REQUEST FOR COUNCIL ACTION

AGENDA SECTION: PUBLIC HEARINGS	ORIGINATING DEPT: PLANNING	ITEM NO. E-12
ITEM DESCRIPTION: General Development Plan #203 by Dallas Backhaus to be known as Wildwood Meadow. The applicant is proposing to develop property located east of Marion Road and south of the intersection of 20 th Street and 37 th Ave SE with single family attached housing, served with public roadways. The property includes approximately 20 acres of land, over half of which is currently designated Floodway. A zoning district amendment is being considered concurrent with this application.		PREPARED BY: Mitzi A. Baker, Senior Planner

GENERAL DEVELOPMENT PLAN

GENERAL DEVELOPMENT PLAN #203 REVISED

WILDWOOD MEADOW	
Zone Change & General Development Plan	
JANUARY 30, 2003	JOB NO: 11979-03
 LAND CONSULTANTS OF SOUTHERN MINNESOTA, INC. 1415 First Avenue N.E. Rochester, Minnesota 55906 (507) 295-5555	
BOUNDARY SURVEYS •	LAND SUBDIVISION •
DEVELOPMENT PLANNING •

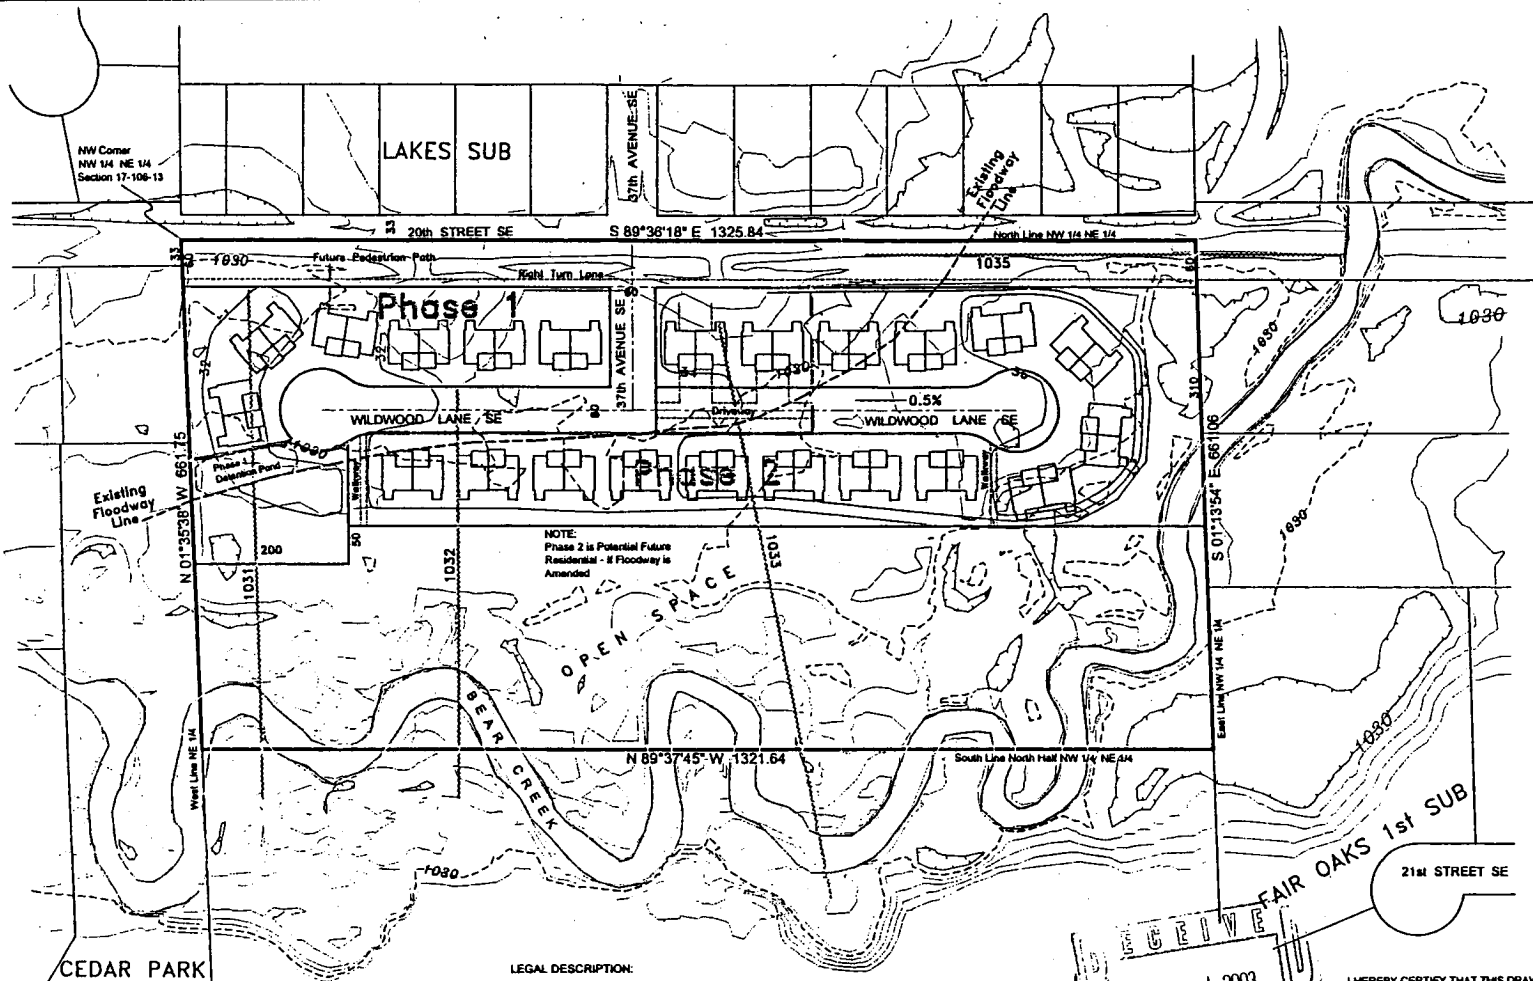
The applicant submitted a Revised GDP on April 1, 2003 addressing the following revisions, as requested by Staff:

- a) Identification of 60 feet of right-of-way for CR 143/20th St. SE;
- b) Alternate road/access design if the Floodway is not amended;
- c) Identification of future turn lanes from CR 143/20th St. SE;
- d) Identification of future pedestrian system along CR 143/20th St. SE
- e) Identification of on-site storm water management, located outside the existing Floodway
- f) Label Phase II as "Potential Future Residential - If Floodway is Amended"

The GDP should be revised to 1) address alternate development and road design if the Floodway is not amended, 2) identify on-site storm water management located outside the Floodway.

NOTE: The new bridge to be constructed over 20th Street will change the location of the Floodway Line. Phase 2 will require the new bridge and channelization grading.

REVISED 03-31-03 Detention, Pedestrian Path, Turn Lane, Driveway

GENERAL DEVELOPMENT PLAN #203

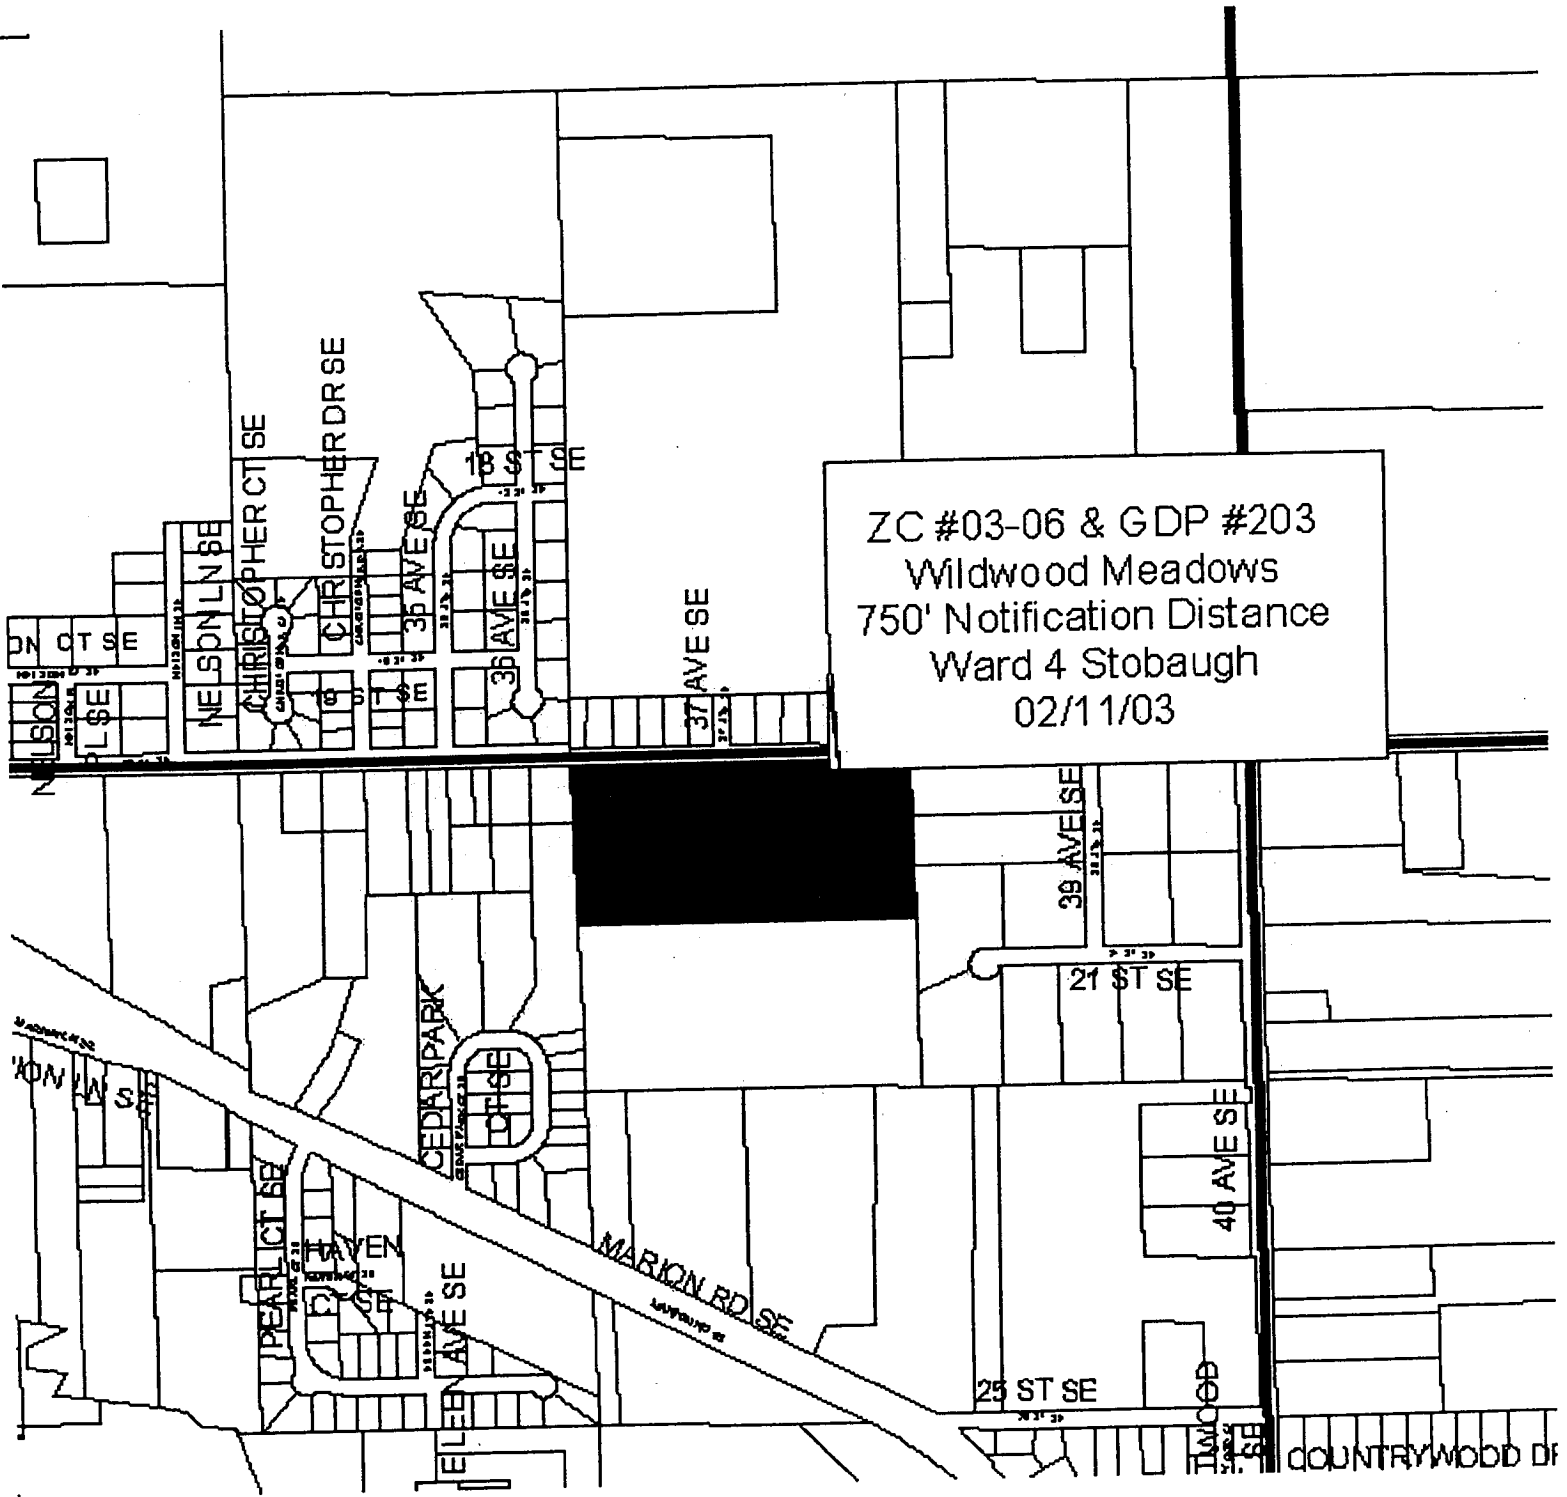
1. Only one of the cul-de-sacs shown on the General Development plan has been given a designation.

RECOMMENDATION: Name the eastern cul-de-sac, and use the roadway type **LANE** and directional of **SE**.
